[Docket No. 99–SW–11–AD; Amendment 39–11113; AD 99–08–07]

Airworthiness Directives; McDonnell Douglas Helicopter Systems (MDHS) Model 369E, 369FF, 500N, and 600N Helicopters

ACTION: Final rule; request for comments.

Figure 1. Contact Socket Inspection

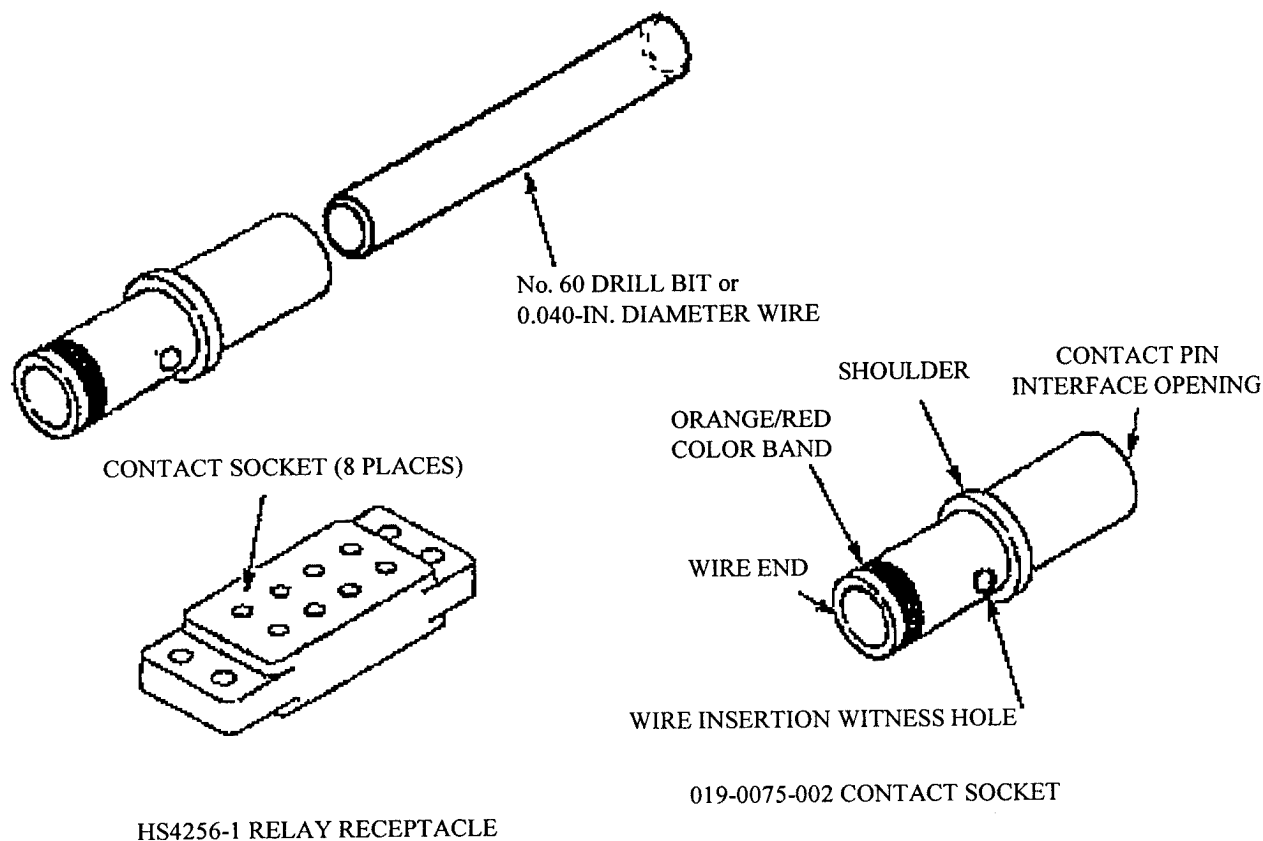
Since the issuance of that AD, the FAA has determined that not all of the previously affected MDHS Model 600N helicopters have the unsafe condition; the prefix "RN" for the serial number for the MDHS Model 500N helicopters is incorrect; and the part number for the relay receptacle was incorrectly stated in Figure 1.

(c) Using a No. 60 drill bit or a 0.040-in. diameter wire as a gauge, attempt to insert the gauge into every contact socket (socket) of each relay. Ensure the gauge is inserted perpendicular to the face of the receptacle, to prevent damage to the receptacle and the socket (Figure 1). If the gauge can be inserted into a socket, it is unairworthy and must be replaced with an airworthy socket, P/N 019-0075-002.
